TOP VIEW OF WING ARMORING

09-14 LATEST REVISION DATE	
	STANDARD DESIGN - 30' ROADWAY, SINGLE SPAN BRIDGE PRETENSIONED PRESTRESSED CONCRETE BEAM BRIDGES APRIL, 2012
	WING ARMORING DETAILS A & B BEAMS
APPROVED BY BRIDGE ENGINEER 	H3051-41-12

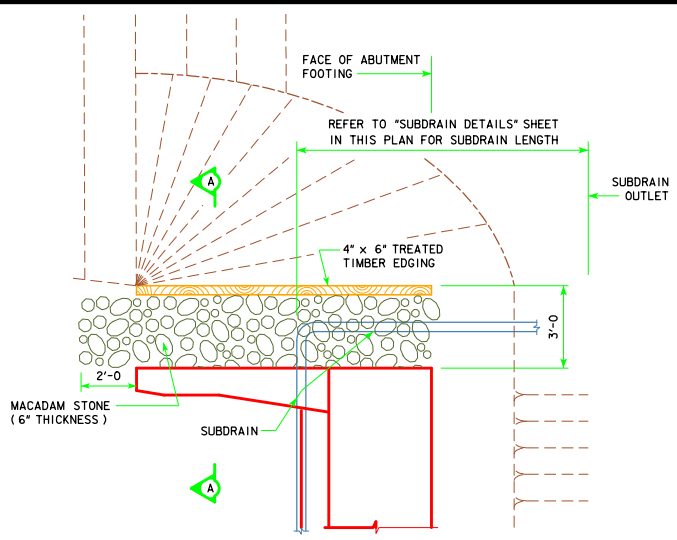
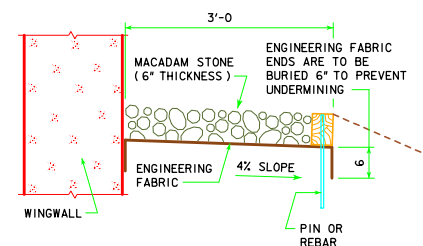
REVISED 09-14 - THE MACADAM STONE AREA WAS MODIFIED TO EXTEND 2 FEET IN FRONT OF THE BRIDGE WING.
